EXTRA INFORMATION REQUESTED BY COUNCIL

This drawing is issued upon the condition it is not copied, reproduced, retained or disclosed to any unauthorised person either wholly or in part without prior consent in DA RE SUBMISSION

CHANGE OF USE TO EXIST. INDUSTRIAL BLDG INTO A VEHICLE SMASH & MECH. WORKSHOP.

SITE PLAN & SITE ANALYSIS PLAN

SITE PLAN 1:200

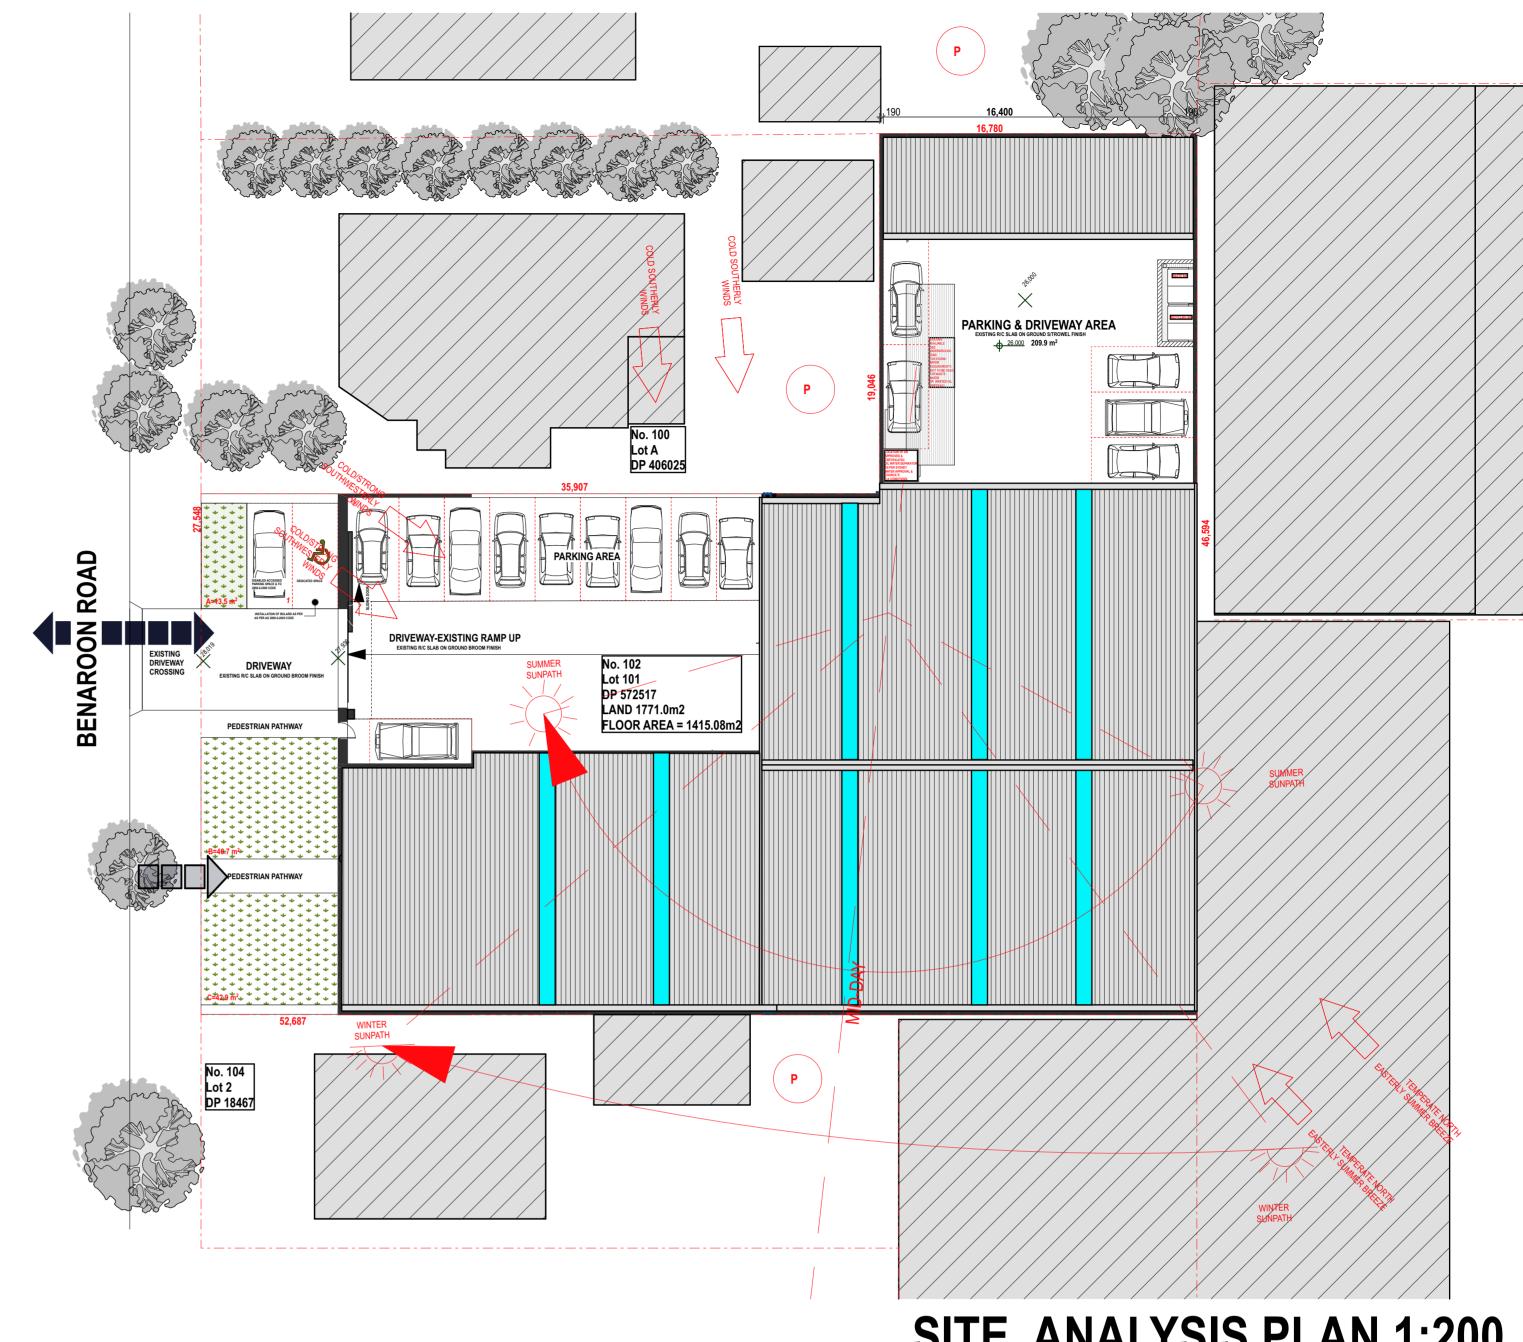
Working bay B and D are obstructed by parking space 27, 26 and vehicle repair working bay number E. This is to be resolved in amended plans.	Plans have been altered accordingly.
Furthermore, it is not clear how loading and unloading will happen within the site and how forward entry and exit is feasible for the loading truck. You are required to submit a swept path analysis demonstrating feasibility.	Plans have been altered accordingly.
